DESIGN & ACCESS STATEMENT

137 OXFORD ROAD,
MANCHESTER M1 7DY

1.5 COMMENTS & RESPONSES

Previous Double Storey Extension

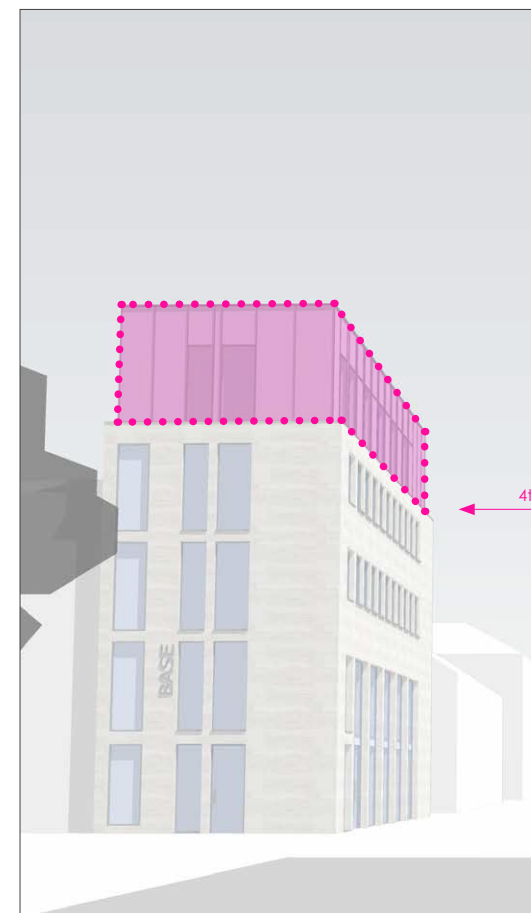
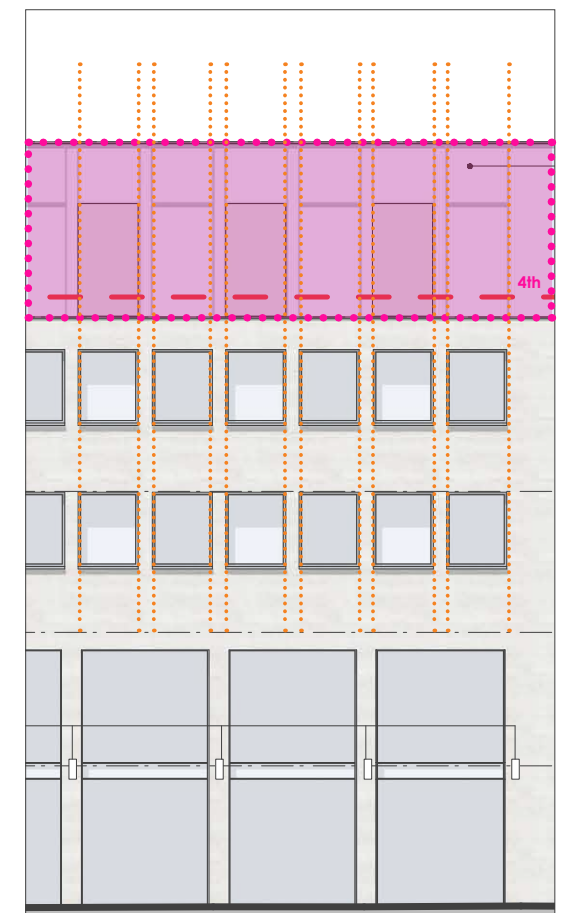
EXTENSION The extension must be a single storey, lightweight, mainly glazed and set back from the facade. It must also respond to the architectural design of the existing building.

EXTENSION 21st have taken on-board this comment and have therefore proposed back sprayed glass insulated units to a single storey extension which will be set back from the main facade. New windows will also align with existing openings to respond to the existing architectural design.

New Ground Floor Front Glazing

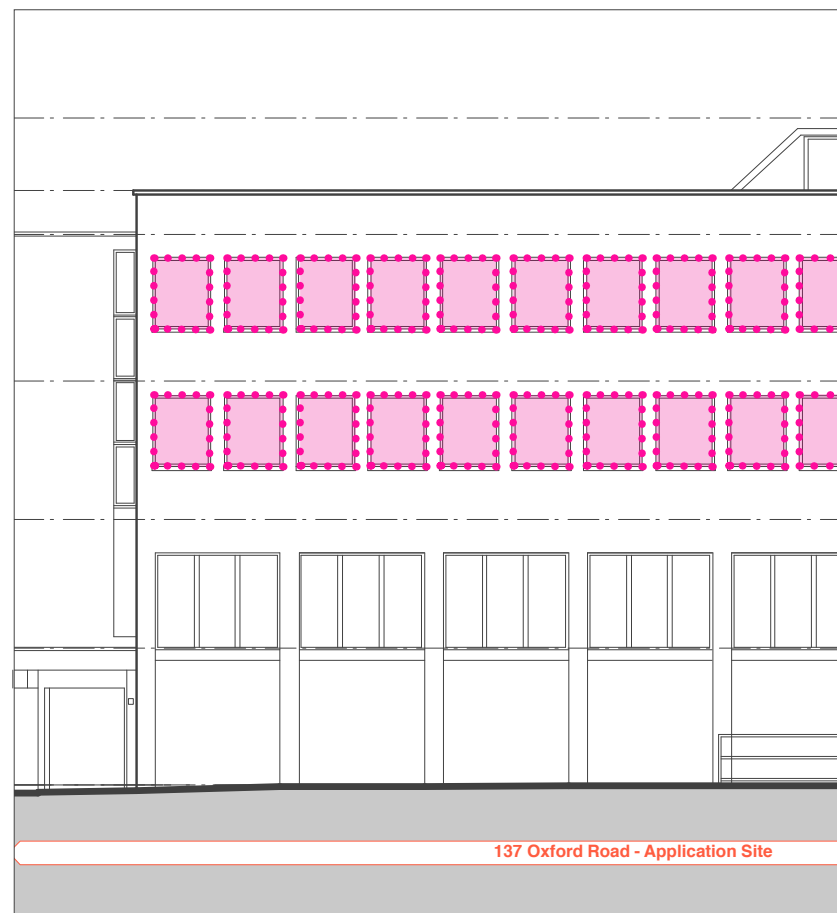
FRAMELESS GLASS Frameless glass must be used within the front floor openings

FRAMELESS GLASS 21st have taken on-board this comment and have therefore proposed frameless glass within the front ground floor openings of the commercial unit.

Proposed Front Windows

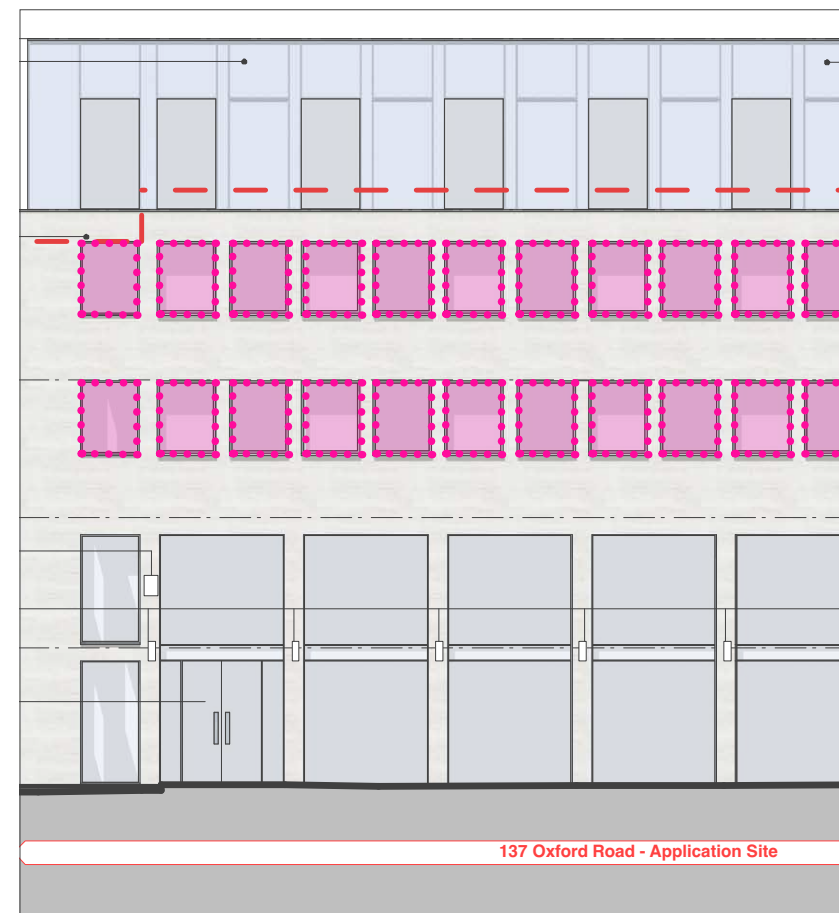
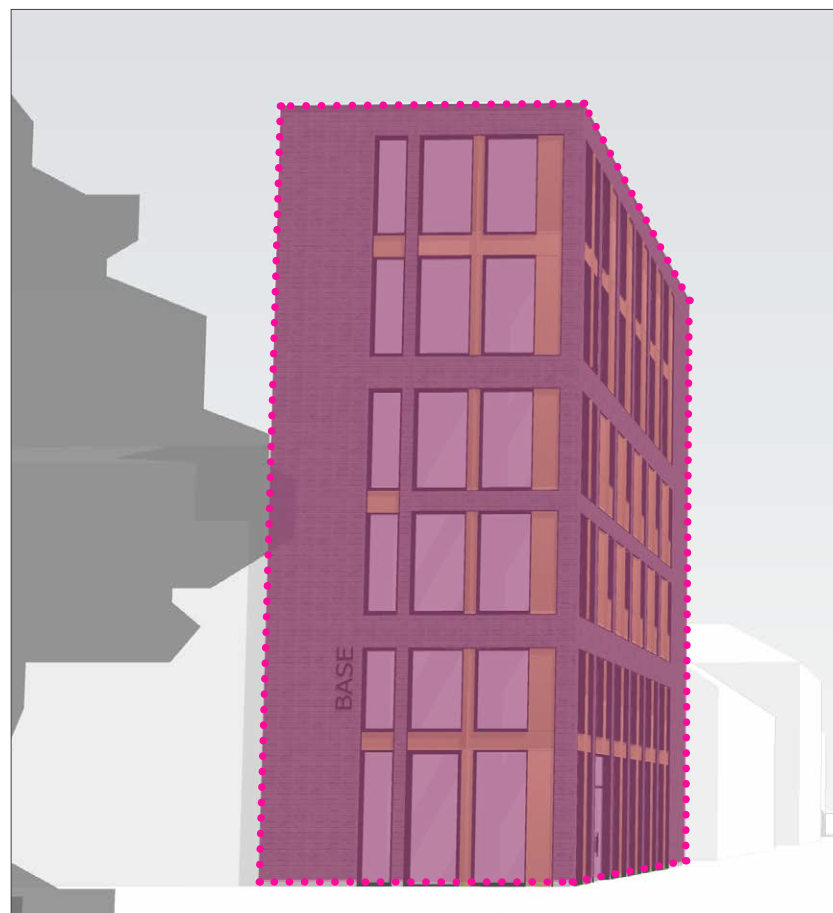
EXISTING WINDOWS Existing window openings must be retained.

EXISTING WINDOWS Existing window openings are being retained and new grey windows are being proposed to replace the existing.

New Proposal (existing stone cladding)

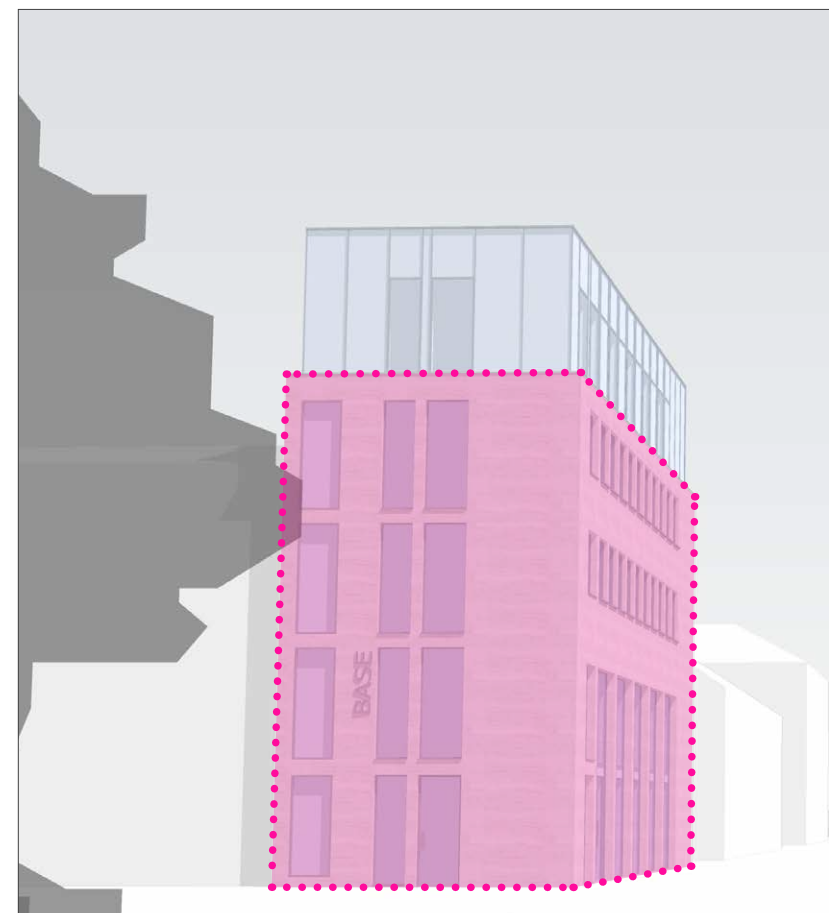
CLADDING The existing elevational material must be retained and cleaned and must not be over clad.

CLADDING 21st have taken on-board this comment and have therefore proposed to retain, clean and repair where necessary the existing stone cladding.
